OWNER:	TELANGANA STATE POWER GENERATION CORPORATION LTD. HYDERABAD - TELANGANA, INDIA			
CONSULTANT:	DESEIN PRIVATE LIMITED			
PROJECT:	BHADRADRI THERMAL POWER STATION 4 x 270 MW, UNITS-1 TO 4, MANUGURU, TELANGANA, INDIA			
EPC CONTRACTOR:	BHARAT HEAVY ELECTRICALS LIMITED INDUSTRIAL SYSTEMS GROUP ISG-BANGALORE			
TITLE:	G.A OF TP-3 WITH LOAD DATA			
SCALE:	BHEL JOB NO. IS-1-14-2007			
	BHEL-ISG IS-1-GA-691-104-M021 DRG.NO.:			
				REV. 01

COMPLIANCE TO COMMENTS OF DESEIN

ON GA DRAWINGS OF TP-3 R0 SUBMITTED BY BHEL FOR APPROVAL

Ref:	Comments made on GA Drawing prints of TP-3, IS-1-GA-691-104-M021, R0 by DESEIN		
SL NO	DESEIN COMMENTS.	COMPLIANCE / CLARIFICATIONS BY BHEL	REMARKS
	COMMENTS MARKED MEMO		
1	Monorail shall be projected 3 m from the out side sheeting of the transfer tower. Please correct.	Noted & revised.	
2	Please indicate the down comer and tramp iron chute clearance from the ground level.	Indicated	
3	Please include details of 1 ton hook provided at various places in the hoist schedule.	In hoist schedule, only details of hoist will be indicated. However, capacity & location is indicated in resp plan & elevation view & same shall be taken care by our civil in drgs.

PLAN AT EL(+20.000M (T.O.C)
FOUNDATION PLAN

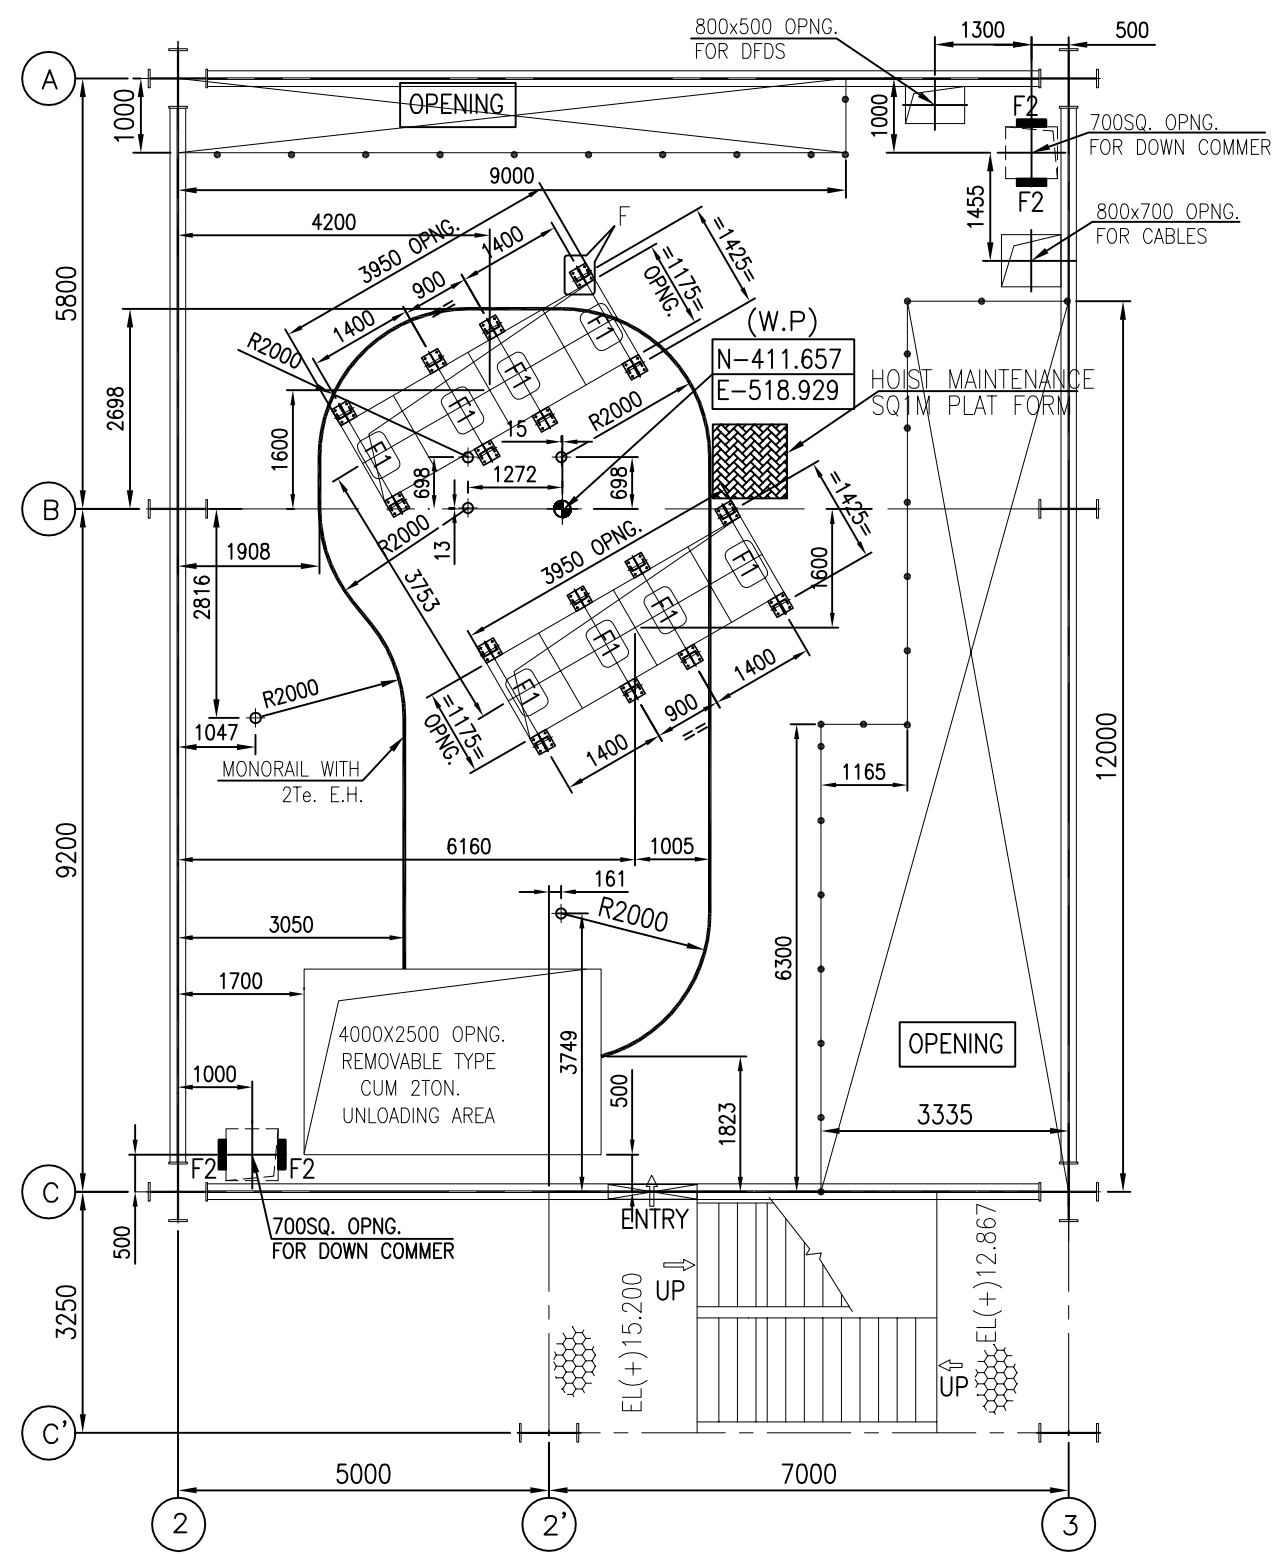
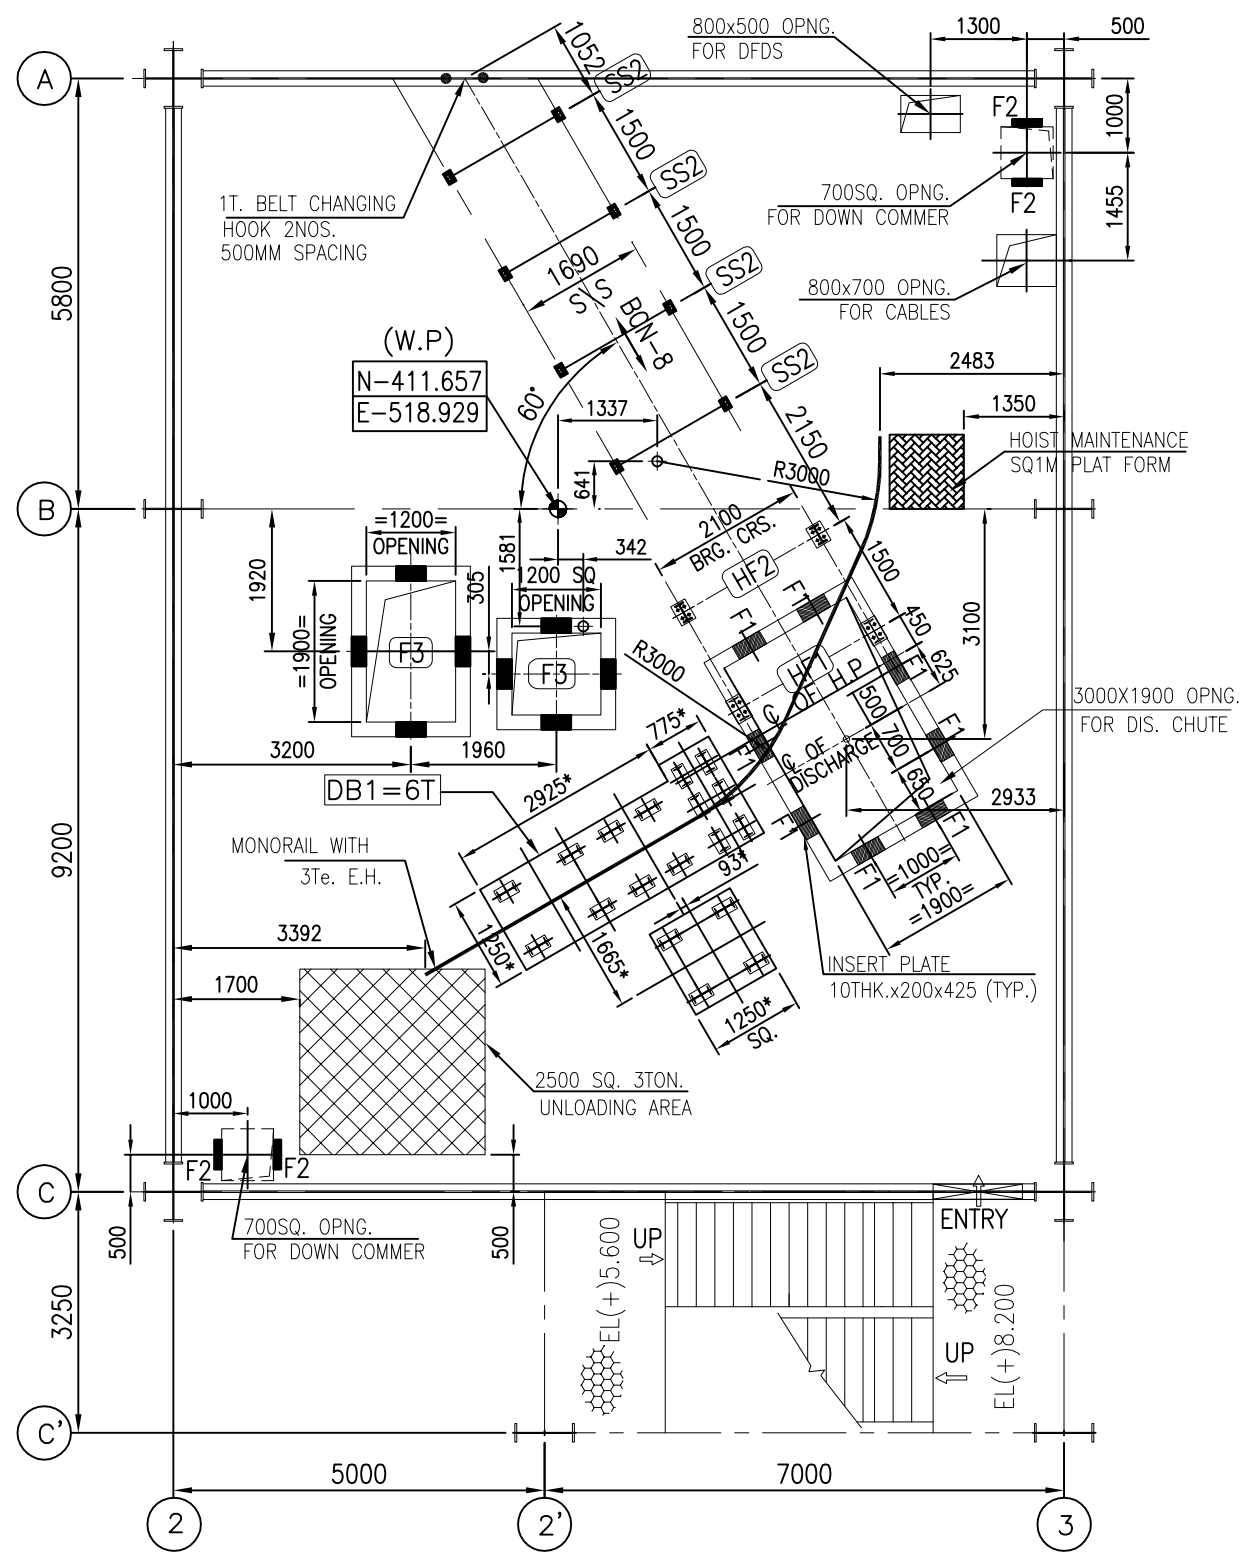
1	20-10-15	REVISED AS PER DESEN COMMENTS DATED 18-7-15	J.S.	M.K.N
R.No:	DATE	BRIEF RECORD	BY	APPD
REVISIONS

- △ 8. FOR DS/SW/DW SYSTEM, SEPARATE DETAILED DRGS. WILL BE FURNISHED AT LATER STAGE.
9. CIVIL REQUIREMENT INDICATED TENTATIVE.
- △ 10. CURB WALL BE PROVIDED AROUND ALL OPENINGS.
